<b>marantz®</b> <b>SERVICE BULLETIN</b>		Date: 15-May.-2003	Model: PM4200
		Page: 1 / 1	REF.NBR: MZ03-012
Circulation:		Application:	
x for information customer complaint in case of service mandatory .....		See Below	
		Subject: The unit works by the remote controller of other company.	
		Int.ref:

<b>marantz®</b> <b>SERVICE BULLETIN</b>		Date: 17-Jul.-2002	Model: PM4200
		Page: 1/2	REF.NBR: MZ02-009revision
Circulation:		Application:	
x for information customer complaint in case of service mandatory .....		See below	
		Subject: Problem with incorrect operation of MUTE.	
		Int.ref:

Processing figure (Part side view)

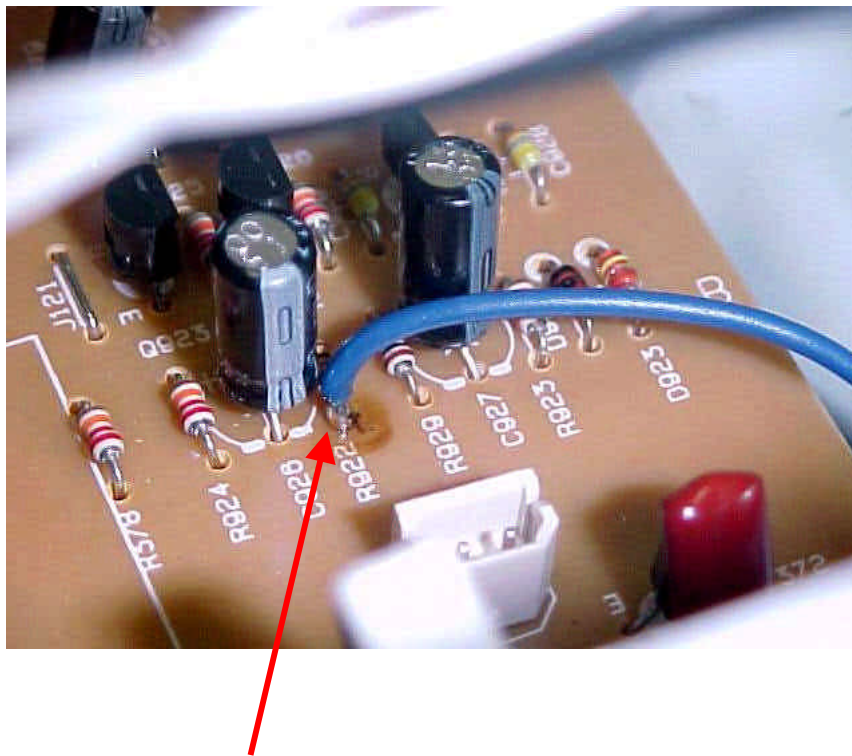
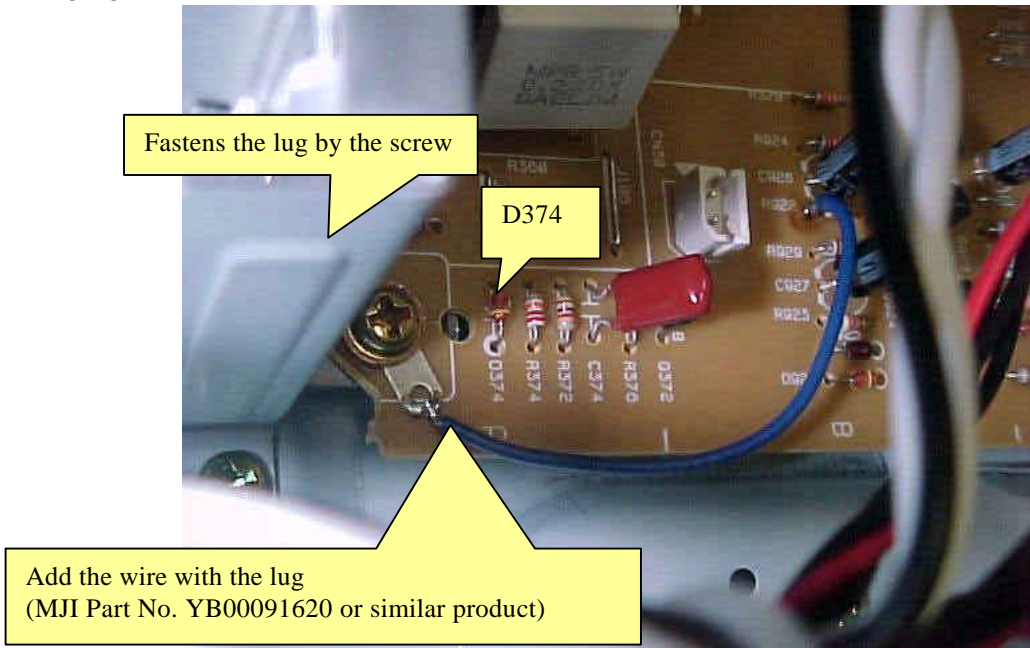
The MUTE LED sometimes blinks and the sounds from output intermit.

Contact error between the bracket (Pos. No. 30) and the ground of INPUT/AMPLIFIER PCB (Pos. No. 29).

Contact to the ground certainly by the wire with the lug.

Please refer to the processing figure of the next page and correct.

**Solder the wire to the ground side lead of the R922 or R929**
